Commission on Community Investment and Infrastructure

RESOLUTION NO. 1-2014

ADOPTING ENVIRONMENTAL FINDINGS PURSUANT TO THE CALIFORNIA ENVIRONMENTAL QUALITY ACT AND APPROVING THE STREETScape PLAN AND THE SIGNAGE PLAN FOR CANDLESTICK POINT AND THE MAJOR PHASE APPLICATION FOR MAJOR PHASE 1 AND CONFORMING CHANGES TO THE PROJECT DOCUMENTS PURSUANT TO THE DISPOSITION AND DEVELOPMENT AGREEMENT WITH CP DEVELOPMENT CO., LP, SUBJECT TO APPROVAL FROM THE AFFECTED CITY DEPARTMENTS AND MAYOR UNDER AND TO THE EXTENT REQUIRED BY THE ICA AND THE PLANNING COOPERATION AGREEMENT; BAYVIEW HUNTERS POINT AND HUNTERS POINT SHIPYARD PROJECT AREAS

Addendum Date: December 11, 2013
Case No.: 2007.0946E
Project Title: Candlestick Point-Hunters Point Shipyard Phase II
EIR: 2007.0946E, certified June 3, 2010
Project Sponsor: CP Development Co., LP
Lead Agency: San Francisco Planning Department/Office of Community Investment and Infrastructure
Staff Contact: Chris Kern – (415) 575-9037
chris.kern@sfgov.org

FIGURE 1 – NON-STADIUM VARIANT 2A 2010 PHASING SCHEDULE^a

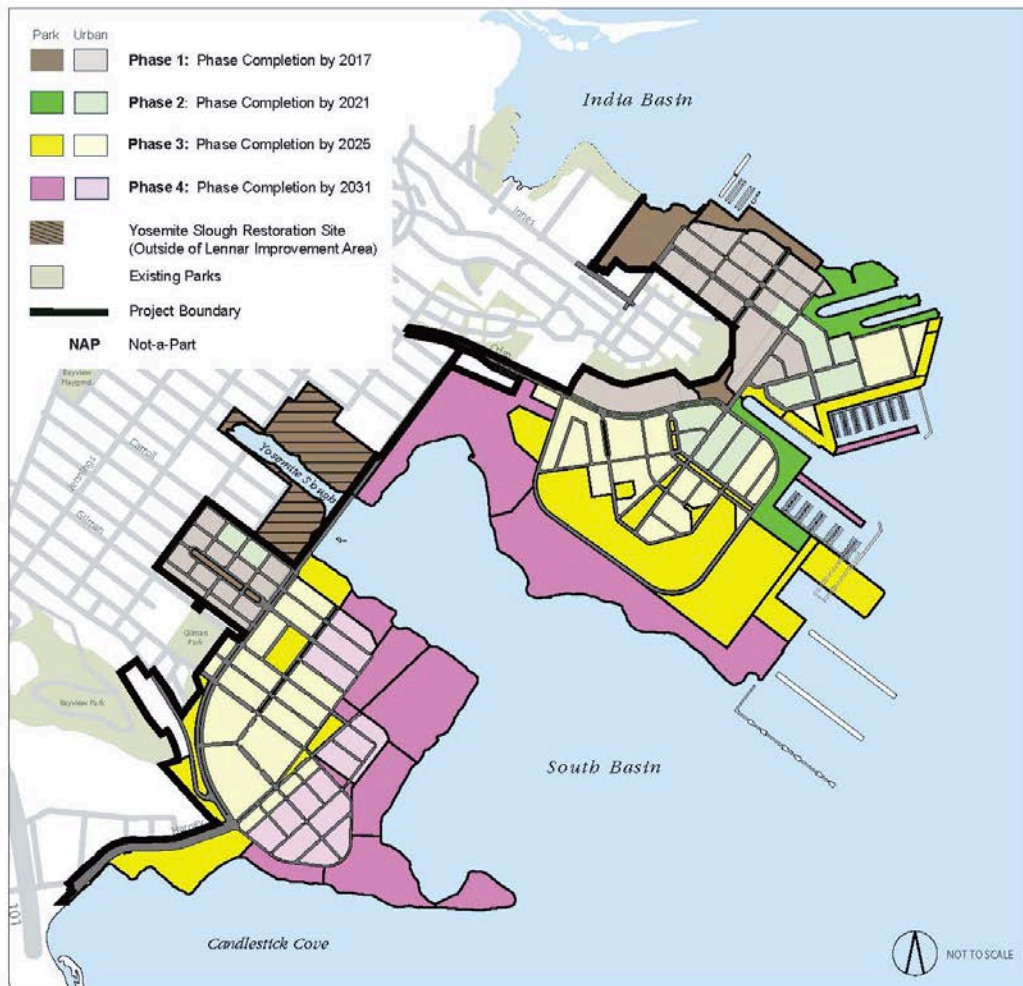
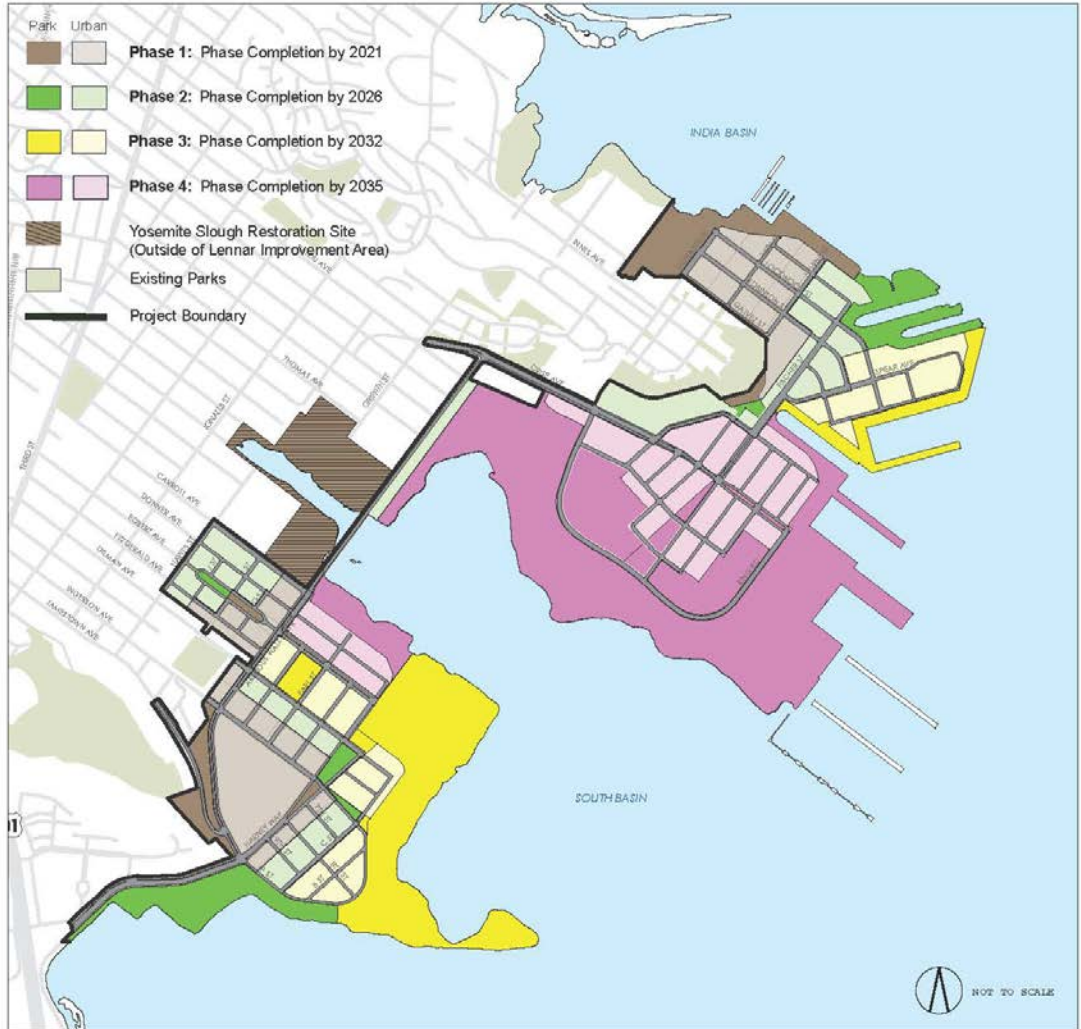
In response to these changes, the project sponsor proposes the following changes to the Project Phasing Schedule:

Under the modified Phasing Schedule, construction activities at Candlestick Point would occur from 2014 through 2035 rather than 2012 through 2031 as described in the FEIR (see **Table 2** below). Off-site roadway, utility, and shoreline improvements would be constructed beginning in 2014 rather than 2013 (see **Table 4** below). The number of construction workers on the site on any given day would vary from a low of 28 during the final stages of vertical development to a maximum of 297 workers during the peak years of development rather than the range of 70 to 328 as anticipated in the FEIR (see **Appendix A**, p. 42 – Construction Activities by Phase). The

Figure 3

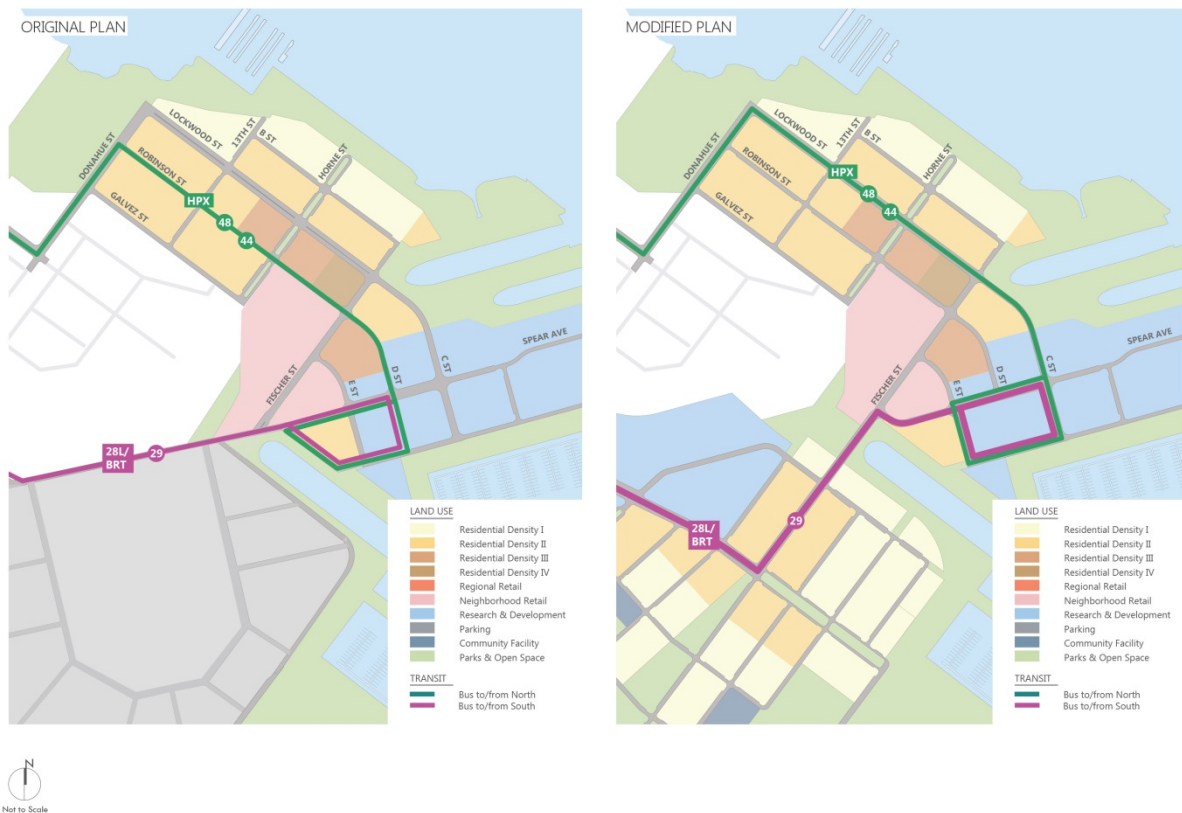
Figure 3 below illustrates the proposed change to the 29 Sunset routing within Candlestick Point. The Project as described in the FEIR called for the 29 Sunset to circulate within the Candlestick Point retail center. Under the proposed project modifications, the 29 Sunset would continue to serve the front of the retail center along Ingerson Avenue, but instead of circulating within the retail center, the route would circulate around the development blocks to the north, so that the 29 Sunset would provide more direct service to the high-density residential buildings proposed near the intersection of Gilman Avenue and Harney Way. This minor routing change is anticipated to increase the Project's transit mode share by bringing transit service closer to more residential units while continuing to provide direct "front-door" service to the retail center.

FIGURE 5 – COMPARISON OF TRANSIT SERVICE RELATIVE TO DEMAND DURING PROJECT BUILD OUT AT CANDLESTICK POINT

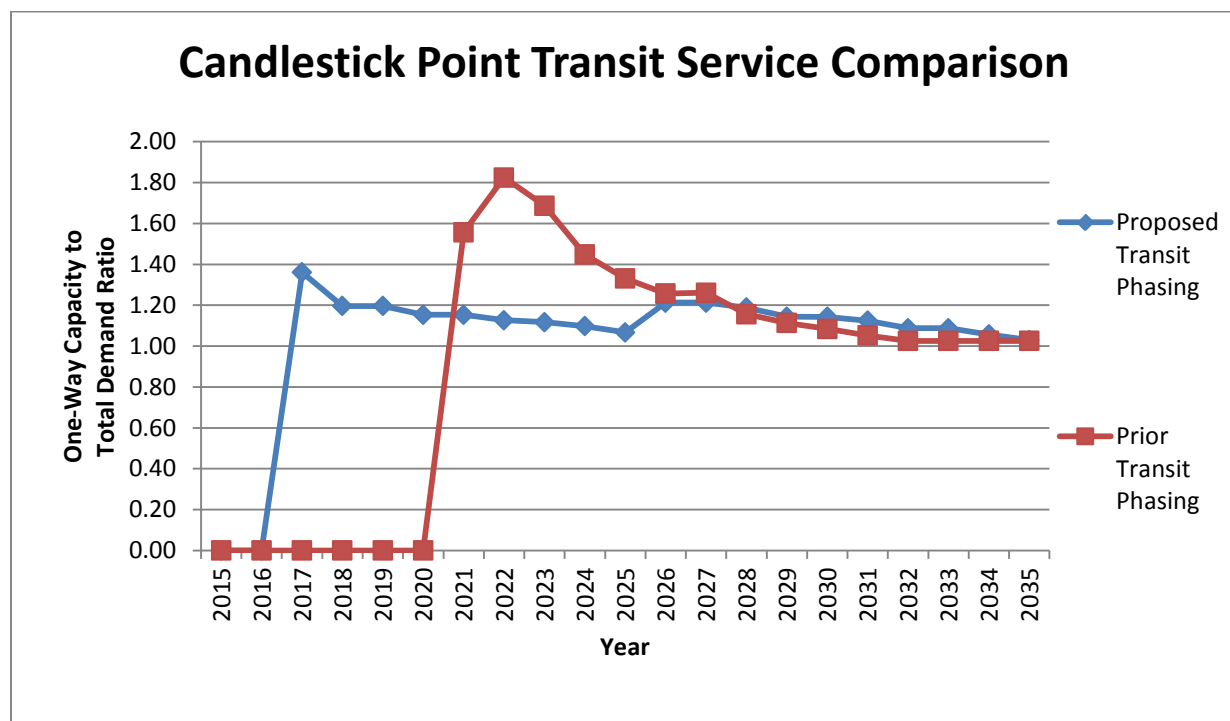
Figure 5 illustrates that with the revised development schedule and revised transit phasing, the level of transit service relative to demand would remain similar to or greater than the identified in the FEIR at build out. Thus, transit would remain an attractive option for travelers in the area.

FIGURE 6 – COMPARISON OF TRANSIT SERVICE RELATIVE TO DEMAND DURING PROJECT BUILD OUT AT HUNTERS POINT SHIPYARD

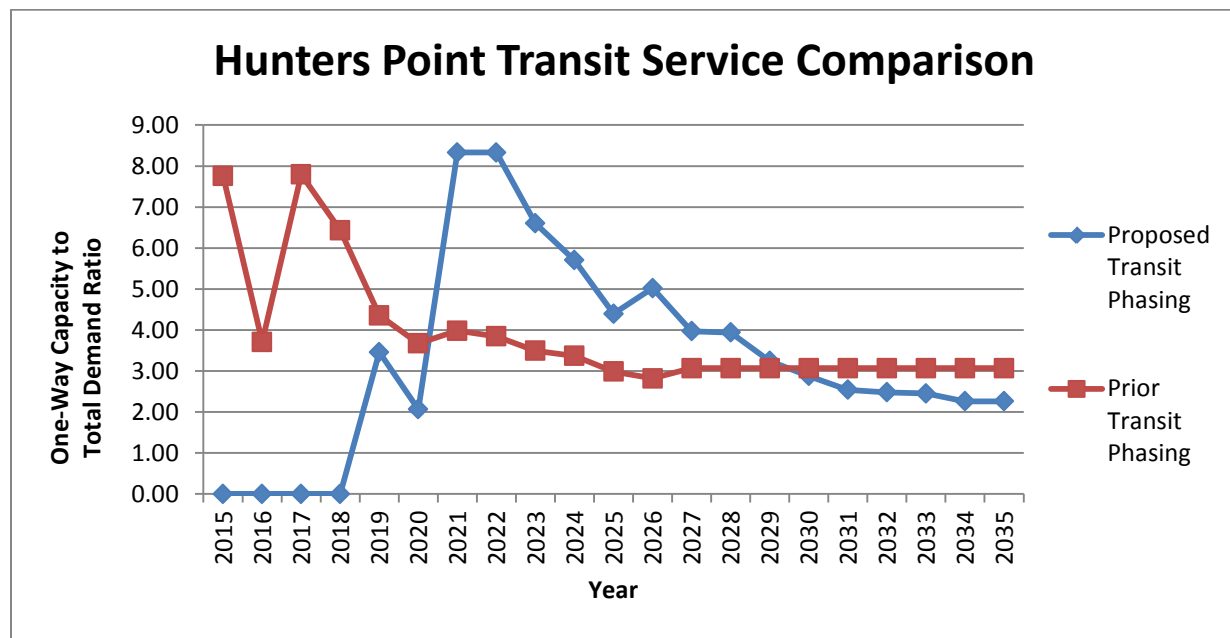
Figure 6 illustrates that once substantial development begins to occur in Hunters Point, the level of transit service relative to demand would exceed what was anticipated in the FEIR, based on the original development and transit implementation phasing until approximately year 2030. After that, the modified project appears to provide less transit service relative to demand than the original project is because the “original” project shown is the stadium alternative and the modified alternative is the Non-Stadium Alternative Variant 2A, which provides the same level of transit service with slightly higher demand than the Stadium Alternative. As a result, transit service would remain an equally attractive option in Hunters Point under the modified project development and transit phasing as was evaluated in the FEIR.

Figure 7

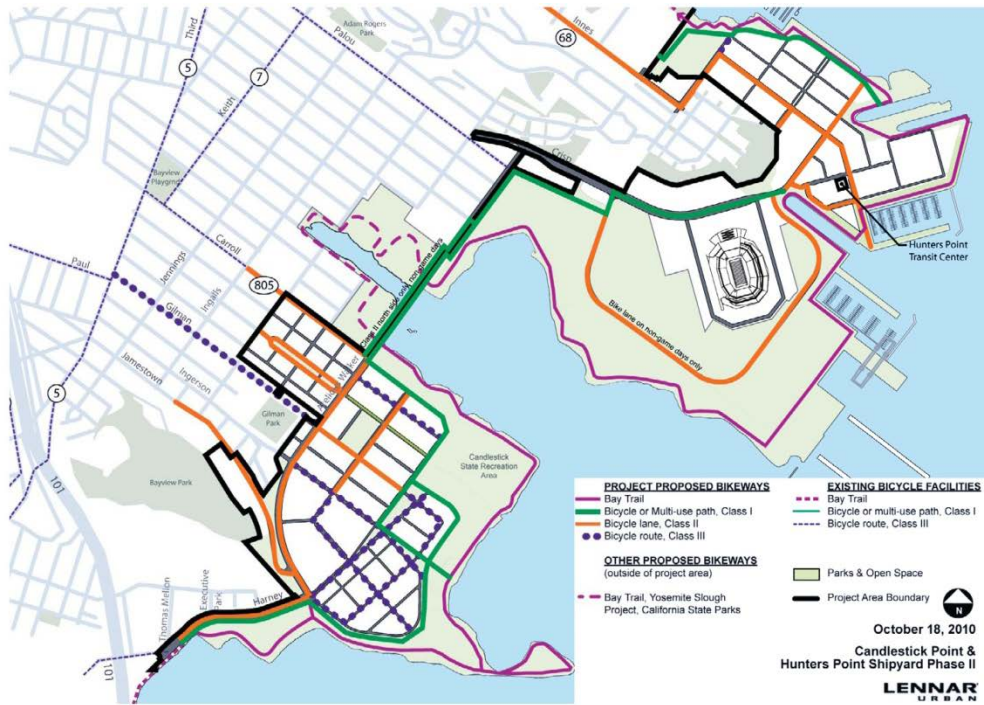
As shown in **Figures 7 and 8**, the modified Project includes refinements to the proposed bicycle network. The changes include replacing the Class II facilities on Arelious Walker Drive with a new, separated, two-way Class I bicycle facility that travels through the heart of the project, and more directly connects the CP and HP project sites. The original bicycle network included Class II facilities on Arelious Walker Drive that connected from the Yosemite Slough Bridge to Harney Way, essentially the only route connecting one end of the Candlestick Point site to the other. The original project also included Class II facilities on Harney Way adjacent to the retail center and the wedge park north of Ingerson Avenue. But, between Ingerson Avenue and Arelious Walker Drive, only Class III facilities were provided, which meant that no dedicated facilities would be provided through the retail core of the project.

The proposed refinements to the bicycle network would replace the Class II facilities on Arelious Walker with a new Class I two-way cycle track that travels through the wedge park and the retail center of the Candlestick Point site. The cycle track would be fully separated from auto traffic, travel along a route with fewer intersection conflicts, and would provide a flatter topographic route. As a result, the proposed cycle track is expected to be more desirable to both commuters and recreational cyclists. The cycle track would continue north through the Hunters Point Shipyard site to the Hunters Point transit center and south along Harney Way toward US 101, where ultimately it could be connected to the Bay Trail and/or other regional facilities. When fully-constructed, the new cycle track facility would provide a dedicated, two-way, Class I facility connecting the Hunters Point Shipyard and Candlestick Point sites to each other and to regional bicycle and transit facilities. Arelious Walker Drive would retain a Class III designation.
